## **CITY OF ROLLINGWOOD COMPREHENSIVE RESIDENTIAL CODE REVIEW COMMITTEE AGENDA**

**Tuesday, July 23, 2024**

# City Council Meeting

July 17, 2024

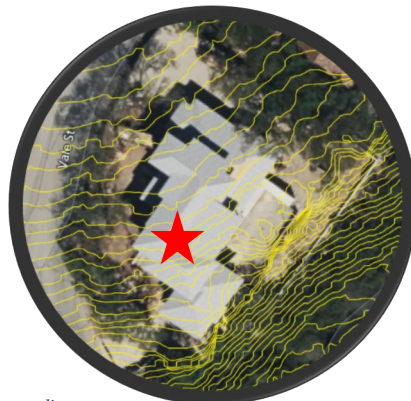
Measurements Per Architecture Plans:  
 Existing Grade beneath Ridge Line = 543'  
 Building Height at Ridge Line = 581'  
**Max Building Height = 38'**

Measurements Per Architecture Plans:  
 Existing Grade beneath Ridge Line = 628'  
 Building Height at Ridge Line = 664' 2"  
**Max Building Height = 36' 2"**

*CRCRC's work said this home would be approved, but in fact, it would **not** be approved*

*CRCRC's work said this home would be approved, but in fact, it would **not** be approved*

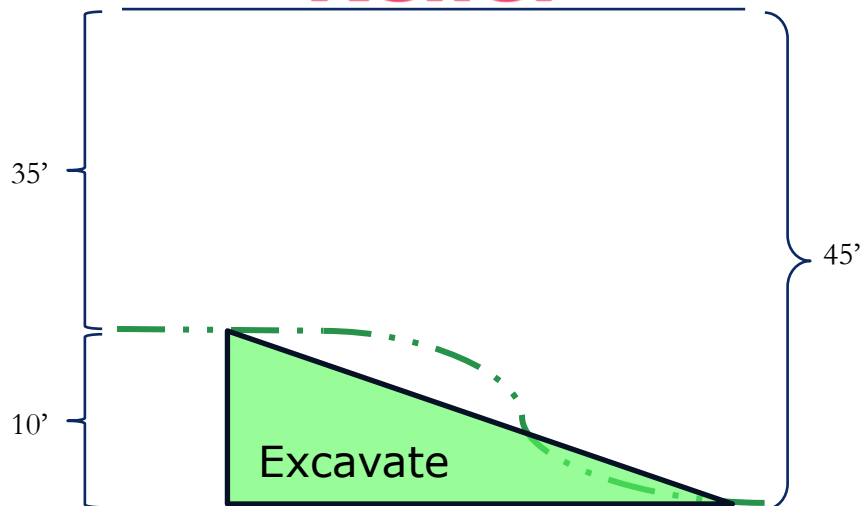
- Within the CRCRC's parallel plane proposal is a new concept, which allows for any excavation that occurs below the existing grade will not count toward the maximum building height calculation, as found in the 07/07/2024 City Council Agenda Packet (p 251)
  - “Figuring Maximum Allowable Height”
    - *Bullet #6\*: “There is no limit to the amount of building that may be added below existing grade by way of excavation.”*
- This proposal has never been discussed in the entire time the CRCRC has existed, but it appeared for the first time at the June 25, 2024 meeting and was pushed forward.
- Even though there were numerous other proposals from the CRCRC members or the public that create “equity” amongst all lots they ignored them and created a rule that further creates “winners” and “losers”

- If a resident's lot is fairly flat but has a material amount of topo at one portion of their lot they could excavate a large portion of their lot gain an additional 10'. This is a huge advantage to this lot

- In the opposite situation, if a resident's lot has topo that quickly drops there is nothing for them to excavate. In this situation they are forced to follow the parallel plane and would have no relief

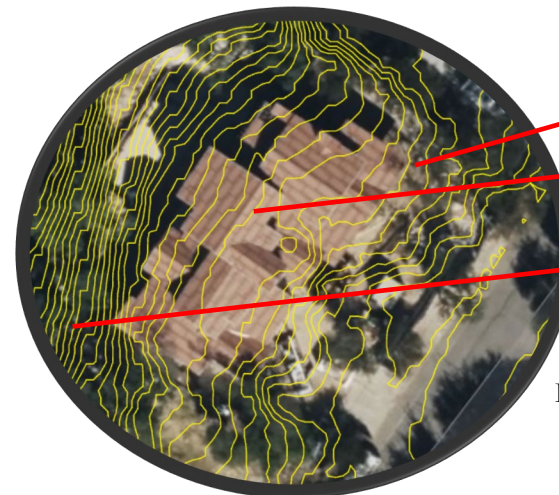
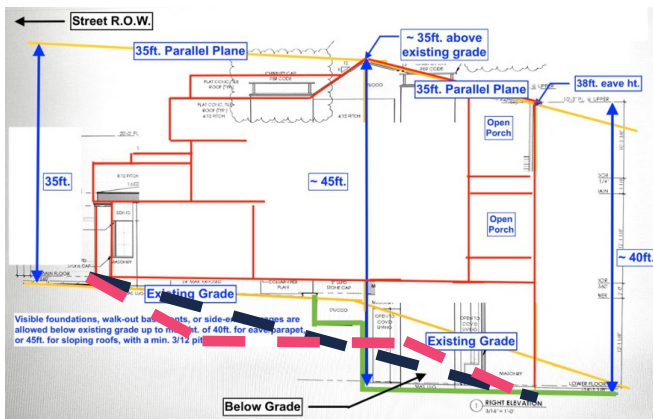
- The two homes below, which were noted on previous pages and were provided in the June 25, 2024 CRCRC Agenda Packet as homes that would be “approved” under the current proposal, in fact, would not be approved
- Both of the homes exceed 35’ height from the existing grade, irrespective of the additional height they received by excavating
  - The home on the left has a **Maximum Height** from the existing grade of **40.85’**
    - Existing Grade beneath ridge line = 622.5’
    - Building Height at ridge line = 663.35’
  - The home on the right has a **Maximum Height** from the existing grade of **37.25’**
    - Existing Grade beneath roof line = 623’
    - Building Height at roof line = 660.25’
- This is another example showing that the CRCRC has does not have a firm grasp of what they are proposing, how it works and how it impacts our lots, neighbors and community

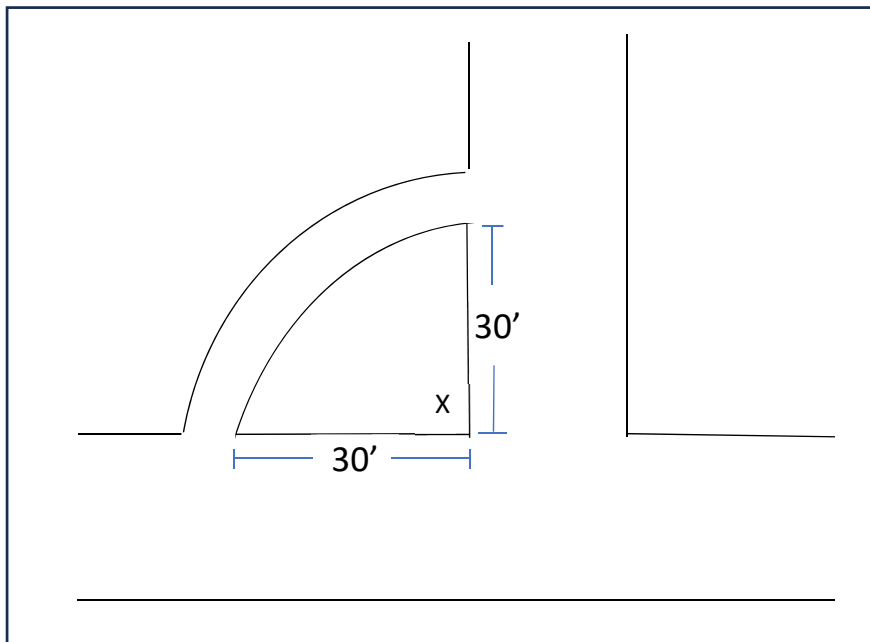
(4) Circular driveways or continuous driveways with more than one curb cut shall be allowed on only one street on corner lots. This includes driveways that cut across corner lots from one street to the intersection street.

*(4) Circular driveways or continuous driveways with more than one curb cut shall be allowed on only one street on corner lots unless safety concerns can be established, reviewed and endorsed by the Rollingwood Police Department and provided that the edge of the driveway closest to intersecting street corner may be no closer than 30 feet to the intersecting corner.*
